Date: December 23, 2019

**ADDENDUM NO. 2**
To Project Bidding Documents for:

**A#03-119686**
**New Student Services Building**
**Compton Community College District**

tBP Project. No. 20987.00

ENLARGED TOILET RM. PLANS & ELEVS. - 1ST FLR

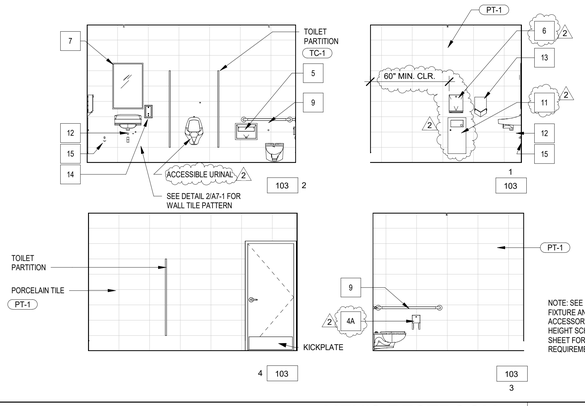
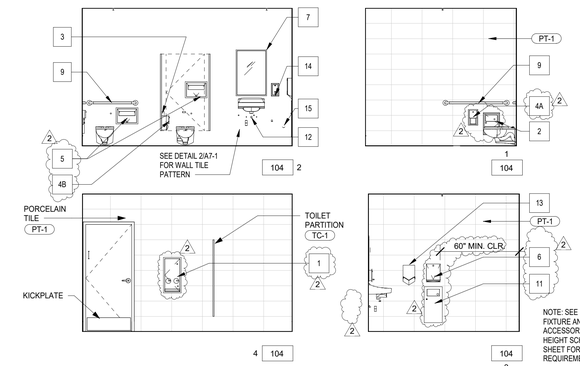
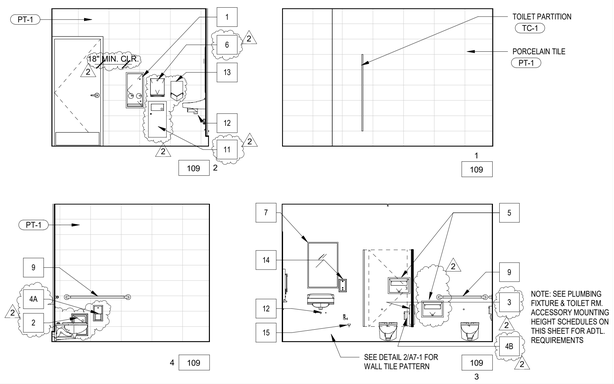
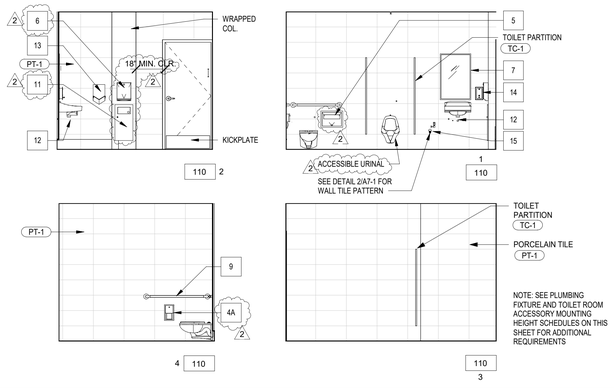
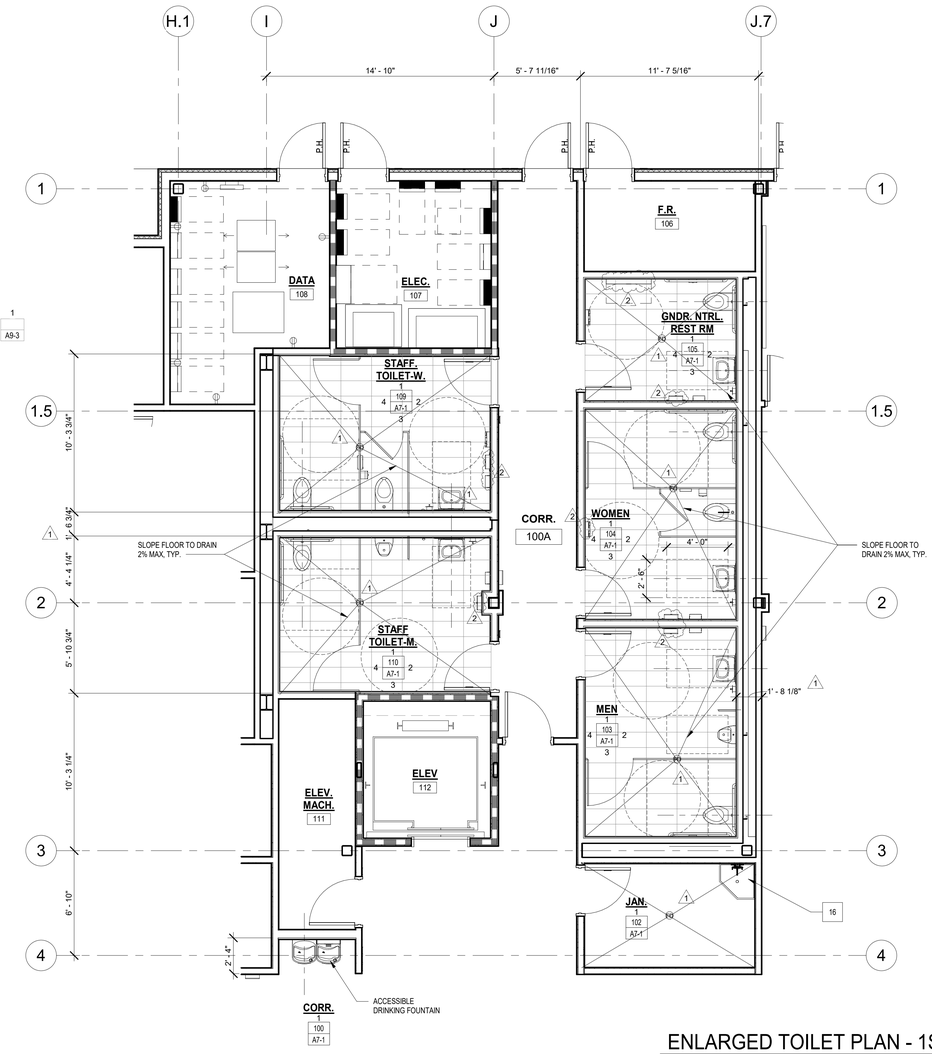
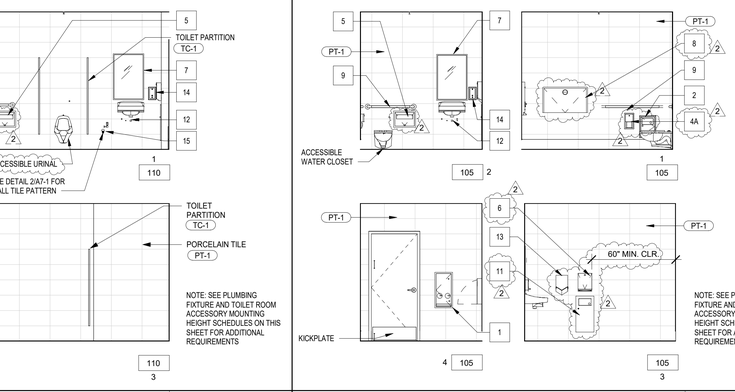
a. Revise accessory keynote schedule.
    b. Revise accessory mounting heights.
    c. Revise plumbing fixture mounting heights
    d. Revised plumbing fixture/ accessory clearances schedule
    e. Interior Elevations 102, 103, 104, 105, 109, and 110: Revise keynotes, add notes, revise locations of accessories, and add accessories.
    f. Revise toilet wall pattern view #3 to #2.
    g. Revise Toilet plan: add/revise locations of accessories

drawing title:
ENLARGED TOILET RM. PLANS & ELEVS. - 2ND FLR

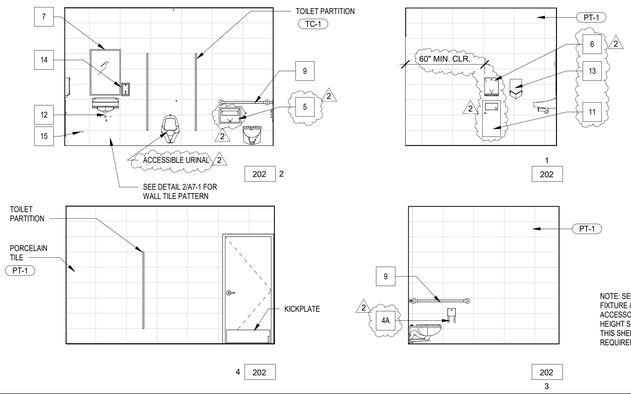
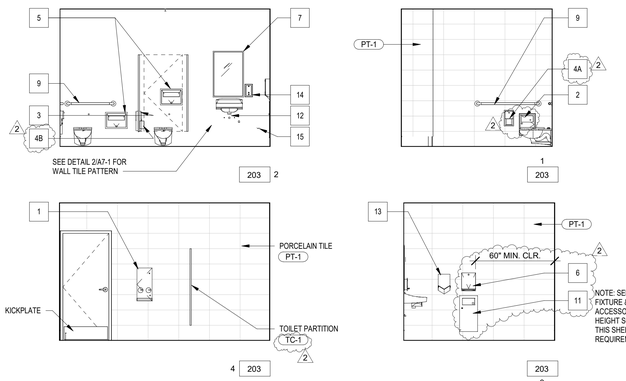
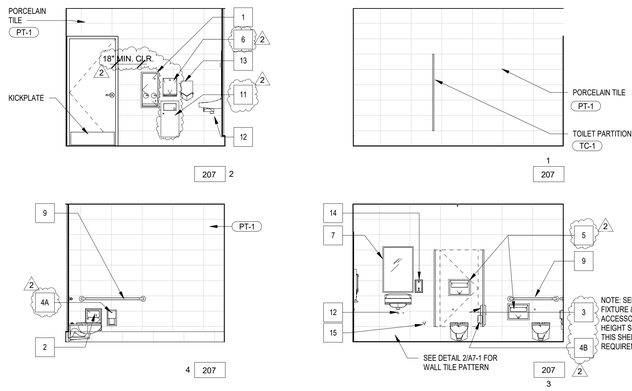
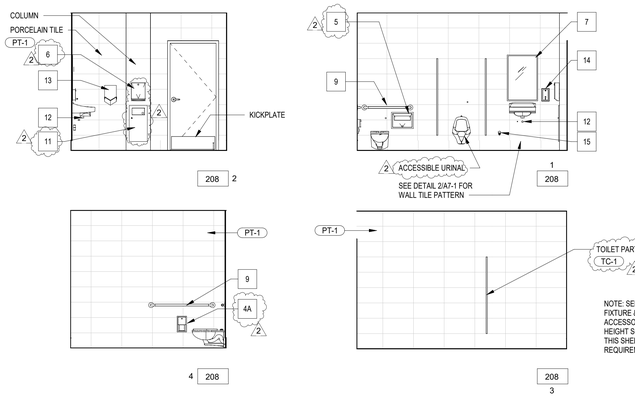
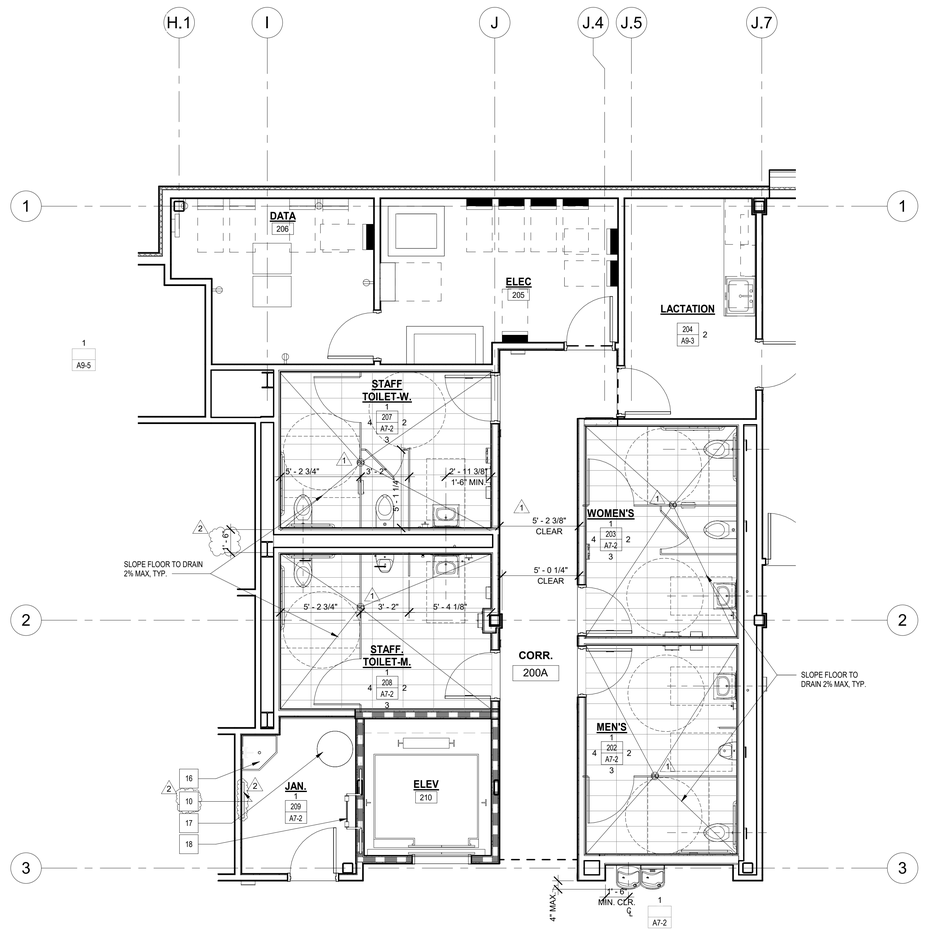
a. Revise accessory keynote schedule.
    b. Revise accessory mounting heights.
    c. Revise plumbing fixture mounting heights.
    d. Revise plumbing fixture / accessory clearances schedule.
    e. Interior Elevations 202, 203, 207 and 208: Revise keynotes, add notes, revise locations of accessories, and add accessories.
    f. Enlarged Toilet Plan: add accessory.

ENLARGED STAIR PLAN & SECTION

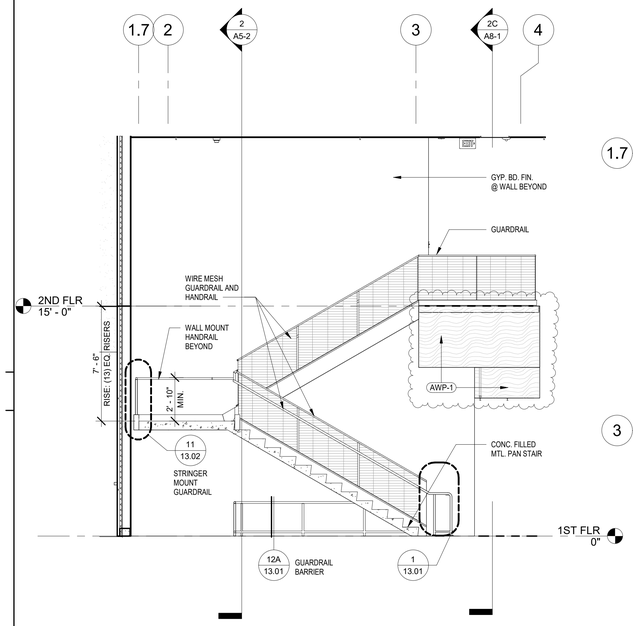
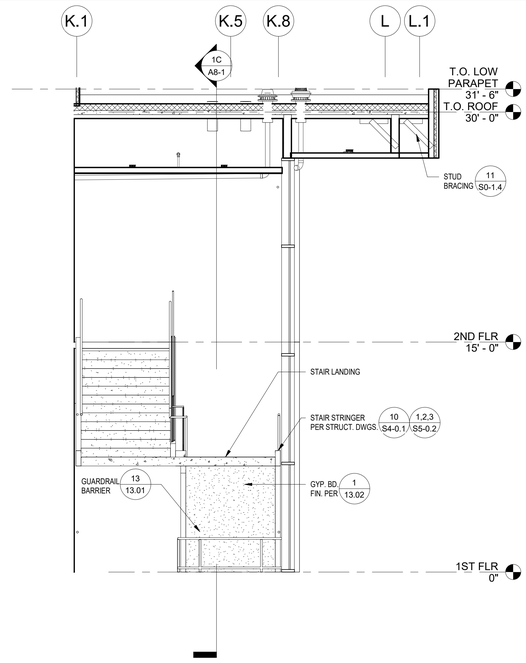
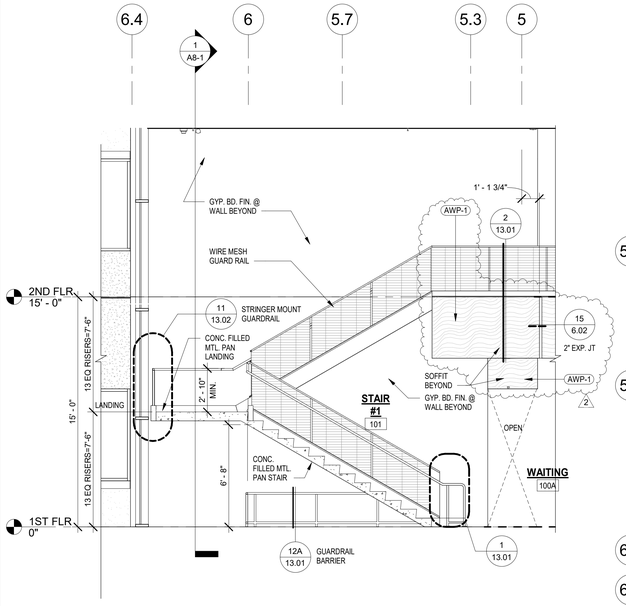
a. Added Seismic Expansion Joint Covers at Corridor 100/Corridor 200 on Stair No. 1 Section and Stair No 2 Section. Added references Accordingly.
    b. Clarified soffit face finishes in Corridor 100/Corridor 200 on Stair No. 1 Section and Stair No. 2 Section. Added finish references accordingly.

drawing title:
INTERIOR ELEVATIONS

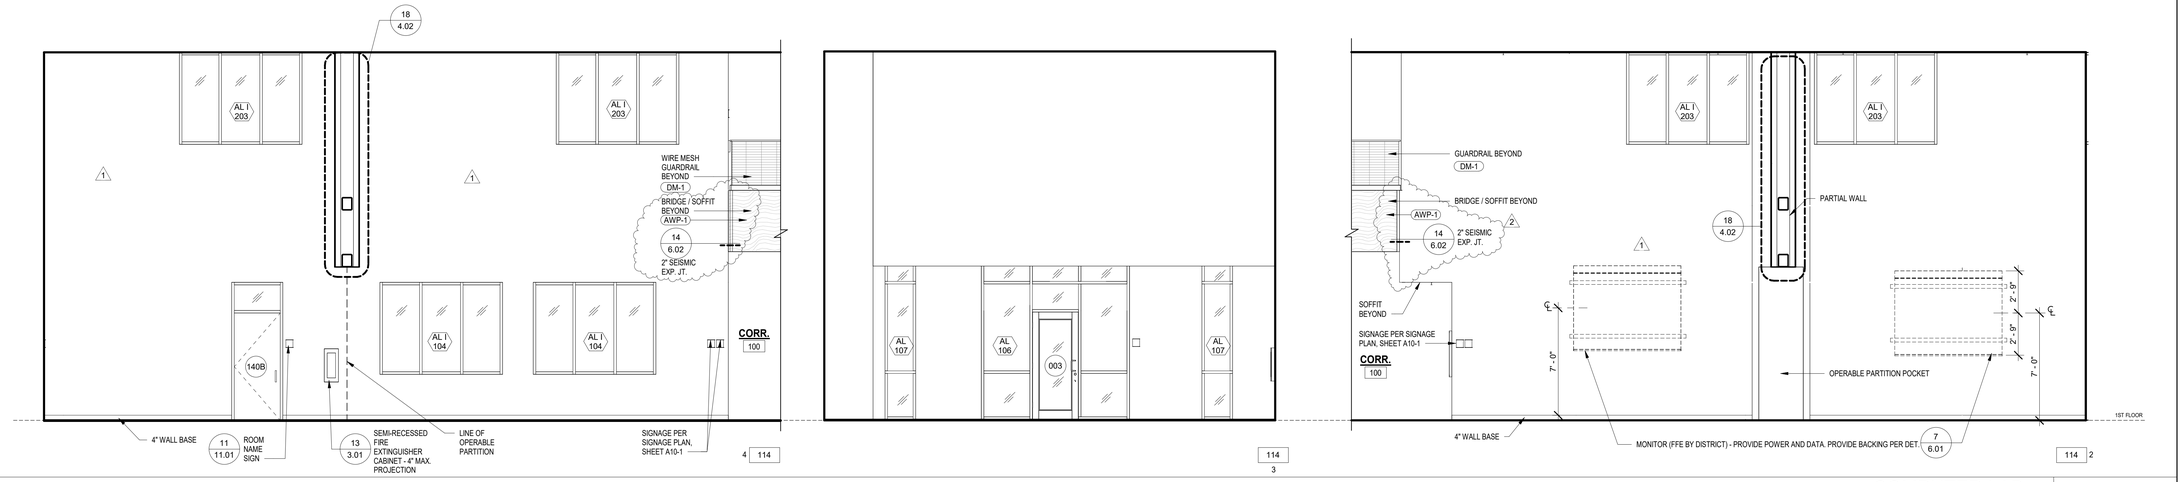
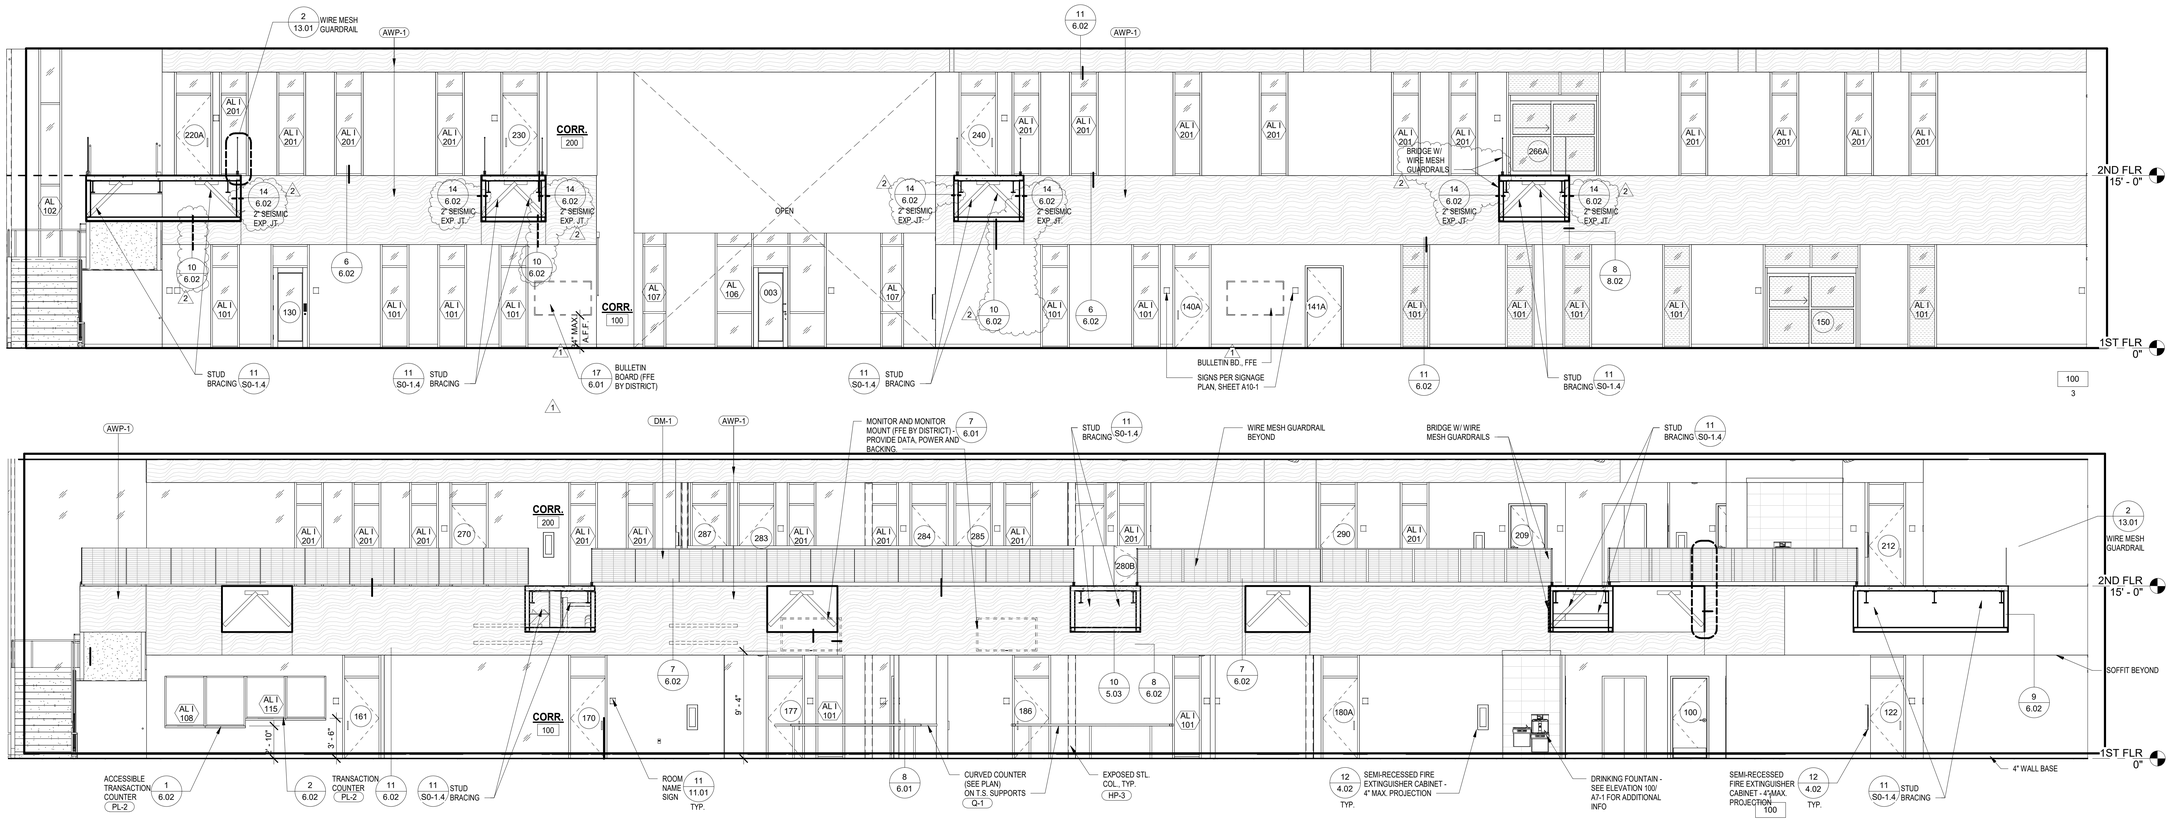
a. Added Seismic Control Joint Covers at Corridor 100/Corridor 200.
    b. Added Seismic Control Joint Covers at Computer Lab 114.

2ND FLOOR SIGNAGE PLAN 2

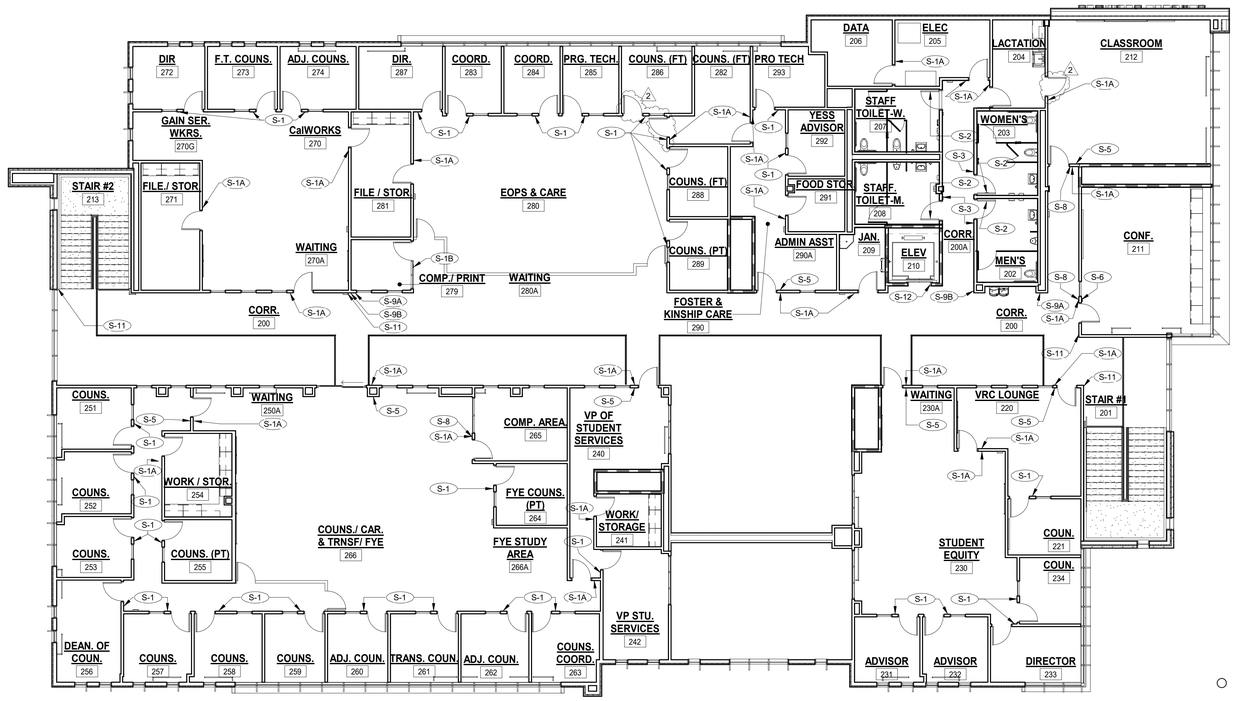
a. Lactation 204: Revise sign Location.
    b. Couns. (FT) 282: Revise sign location.
    c. Couns. (FT) 286: Revise sign location.

CONNECTION DETAIL AT DEMOED CANOPY — SCALE: 3" = 1'-0" — 6

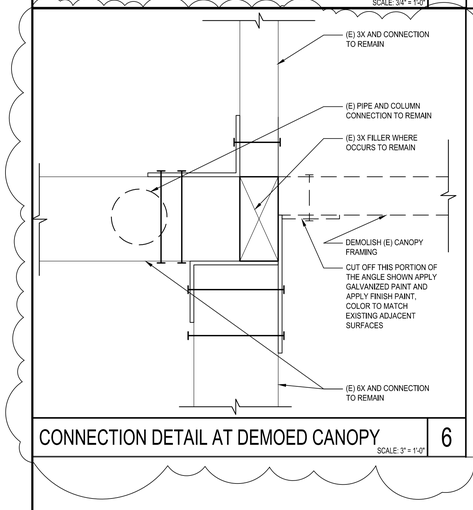
a. Added detail 6.

drawing title:
INTERIOR METAL STUD PARTITION DETAILS

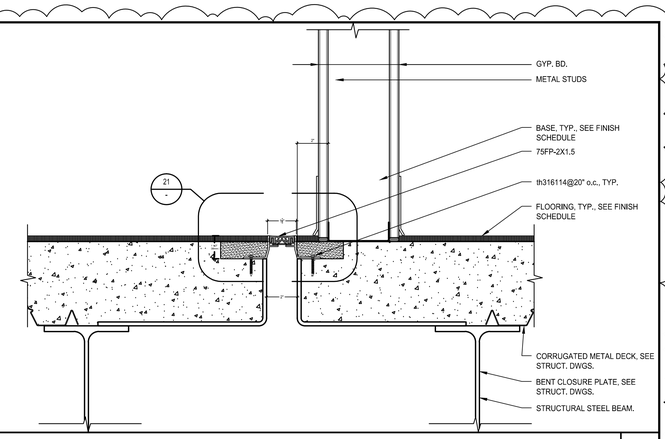
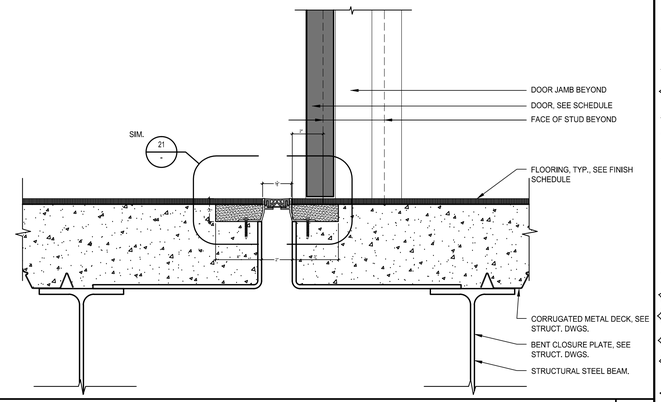
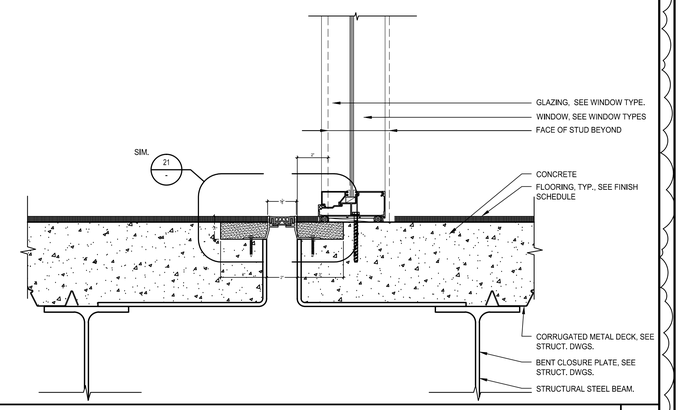
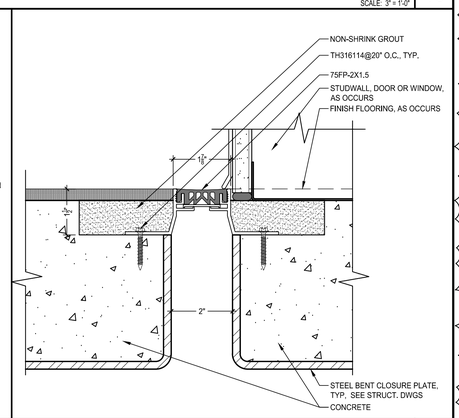
a. Added details 5, 10, 15, 20 & 21.

## SEISMIC EXPANSION JT. COVER AT WALL/SOFFIT 12

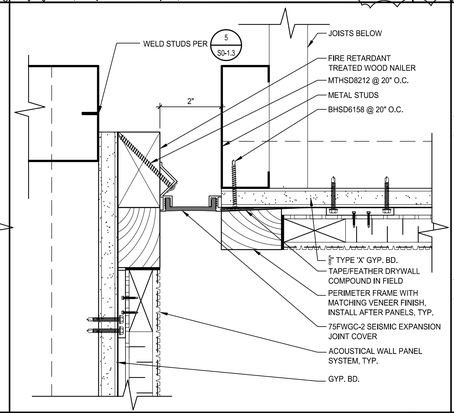
a. Added details 12, 13, 14 & 15.
